# 59-F-35  
W.P. # 74-59  
Hwy. # 401  
CROSSING  
GRAVEL RD.  
CON. # 3  
2 1/4 MILES N.W. OF  
NAPANEE

<u>DEPARTMENT OF HIGHWAYS ONTARIO</u> <u>BRIDGE DIVISION</u>									
<u>COUNTY RD. UNDERPASS</u> <u>2 1/2 MILES WEST OF JCT. HWY. # 41</u>									
KING'S HIGHWAY No. <u>401</u>						DIST. No. <u>3</u>			
<u>CO. LENNOX &amp; ADDINGTON</u>						<u>RICHMOND TWP. BR. #5</u>			
<u>TWP. RICHMOND</u>						<u>LOT 12 &amp; 13</u>		<u>CON. 3</u>	
<u>PRELIMINARY</u>									
APPROVED _____ BRIDGE ENGINEER				SITE No. <u>18-52</u>		W.P. No. <u>74-69</u>			
DESIGN: <u>W.M.</u>		CHECK: _____		CONTRACT No. _____		_____		_____	
DRAWING: <u>V.S.R.</u>		CHECK: <u>D.S.</u>		_____		_____		_____	
DATE: <u>MAY 1963</u>		LOADING: <u>420 516</u>		DRAWING No. <u>D-5268-P1</u>		_____		_____

✓ W.P. 73-59 : County Rd. No. 10 Underpass  
W.P. 74-59 : County Rd. Underpass  
W.P. 177-61 : Mallorytown Rd. Interchange Underpass  
District No. 8

SUBJECT: W. P. 74-59  
Bridge Site #18-52  
County Rd. Underpass  
2.1 miles west of Jct. Hwy. 41  
Hwy. 401. District #8.

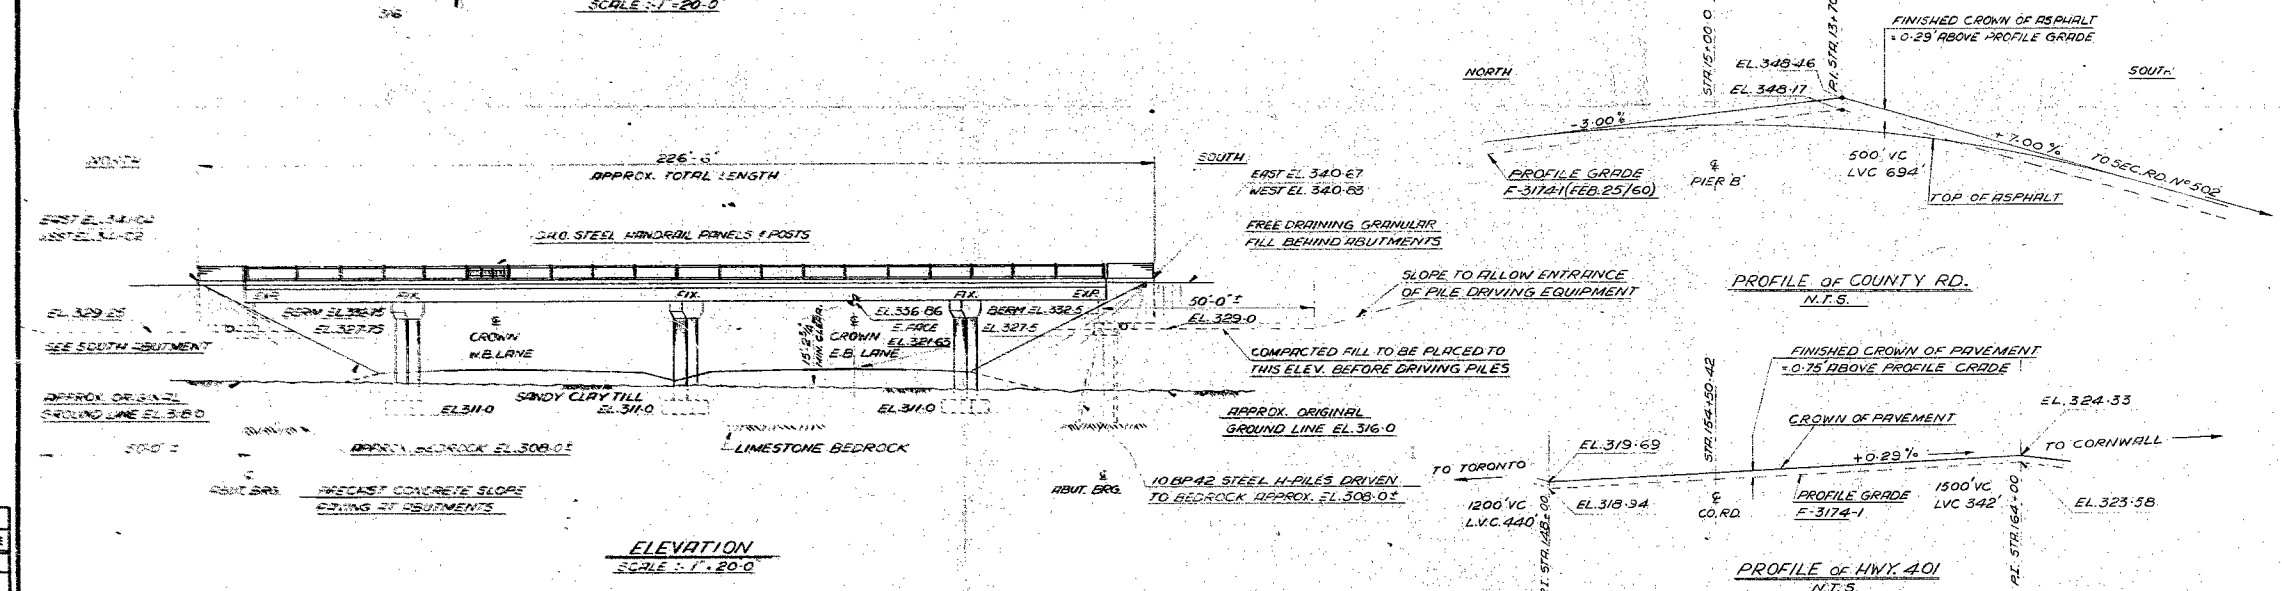
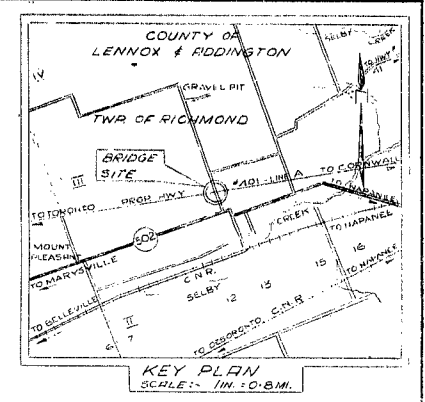
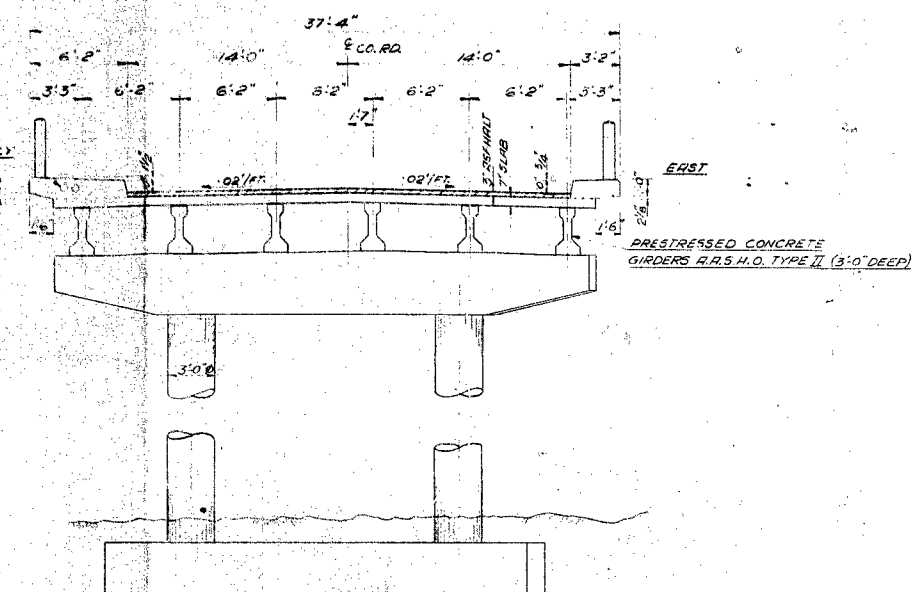
We have received and reviewed the Preliminary Plans for the above-mentioned structures and herewith, submit our comments for your consideration:

At all three sites bedrock was found at relatively shallow depth. The subsoil overlying bedrock is dense and can be considered as good bearing ground.

For the other two structures (W.P. 73-59 and W.P. 74-59), the piers are founded on spread footings resting above bedrock within the overburden, while the abutments are founded on piles driven to bedrock. From the above, it is evident that conditions for the different supports are not identical. In view of the very dense state of packing of the overburden and its relatively small thickness, the difference in support has no significance.

In case of structure W.P. 74-59, the compacted fill would have to be on both abutment locations, in the order of 10 - 13 feet.
